# HISTORIC AND DESIGN REVIEW COMMISSION

**HDRC CASE NO:** 2022-200  
**ADDRESS:** 323 REFUGIO ST  
**LEGAL DESCRIPTION:** NCB 714 BLK 11 LOT S IRR 63.8 FT OF 14 AT 323 REFUGIO  
**ZONING:** RM-4, H  
**CITY COUNCIL DIST.:** 1  
**DISTRICT:** Lavaca Historic District  
**APPLICANT:** Marcello Martinez/1718 Archtiecture  
**OWNER:** Kevin Allison/ALOHA HOME SOLUTIONS INC  
**TYPE OF WORK:** Construction of a rear addition, rehabilitation, construction of a new front porch  
**APPLICATION RECEIVED:** March 31, 2022  
**60-DAY REVIEW:** Not applicable due to City Council Emergency Orders  
**CASE MANAGER:** Claudia Espinosa  
**REQUEST:**

The applicant is requesting a Certificate of Appropriateness for approval to:

1. Construct a new addition to the north side of the house.
2. Repair and patch the existing structure to match the existing condition including altering existing window openings and installing replacement windows on the front façade.
3. Construct a porch to the front of the existing building.

# Rendering submitted June 1, 2022

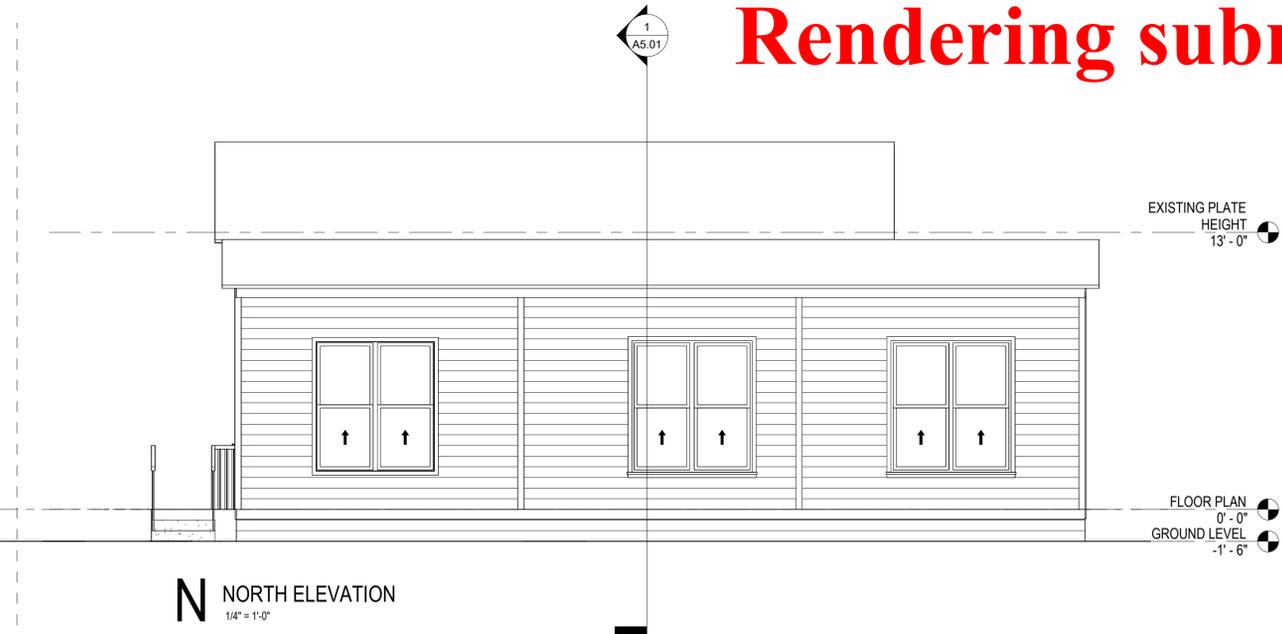
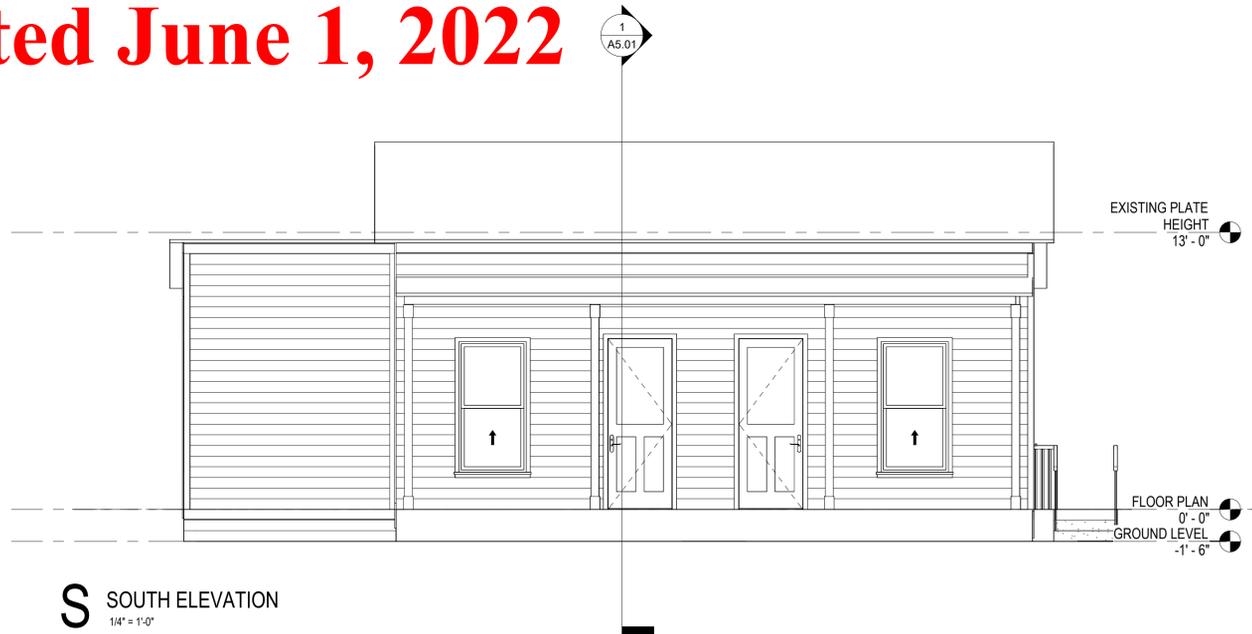
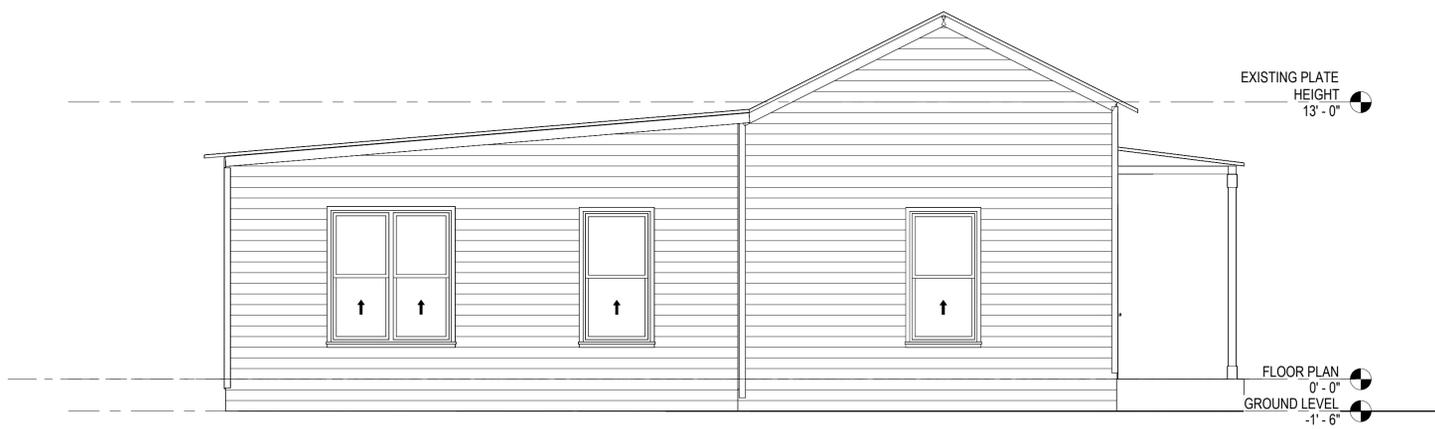
- d. **FRONT PORCH CONSTRUCTION** – The applicant has proposed construct a shed roof front porch that spans the center of the front facade and uses the existing concrete front porch slab. The applicant has proposed to construct the front porch with a composition shingle shed roof that is an extension of the existing roof form and 6”x6” wood columns. The 1896 Sanborn Map shows that the structure originally featured a full-width front porch. Google Street View photos from 2011 show a modified front porch in the same configuration as the proposed front porch but with a traditional shed roof located below the front façade roofline on metal post supports. Guideline 7.B.v for Exterior Maintenance and Alterations states that porches, balconies, and porte-cocheres should be reconstructed based on accurate evidence of the original, such as photographs. If no such evidence exists, the design should be based on the architectural style of the building and historic patterns. Staff finds that the new front porch should feature a shed roof that is distinct from the roof on the primary structure. Additionally, the installation of a full-width front porch to match the original front porch would be appropriate.

- g. **ADDITION: ROOF MATERIAL** – The applicant has proposed to install a composition shingle roof on the rear addition to match the existing roof material on the primary structure. Guideline 3.A.iii for Additions

stipulates that original roofs should be matched in terms of form and materials. For example, when adding on to a building with a clay tile roof, the addition should have a roof that is clay tile, synthetic clay tile, or a material that appears similar in color and dimension to the existing clay tile. Staff finds the proposal consistent with the Guidelines.

- i. ADDITION: NEW WINDOWS AND DOORS: SIZE AND PROPORTION – The applicant has proposed to install windows with traditional proportions on the north, east, and west elevations and a small window on the south (front) elevation of the addition. The applicant has proposed to install one (1) full-lite wood door on the east elevation and one (1) set of full-lite wood French doors on the north (rear) and west elevations. Staff’s standard window specifications state that new windows should feature traditional dimensions and proportions as found within the district. Staff finds that the applicant should modify the proposal to feature windows of traditional proportions on the south (front) elevation. The applicant has agreed to maintain the transom windows on the south (front) elevation, which are not present on the renderings.
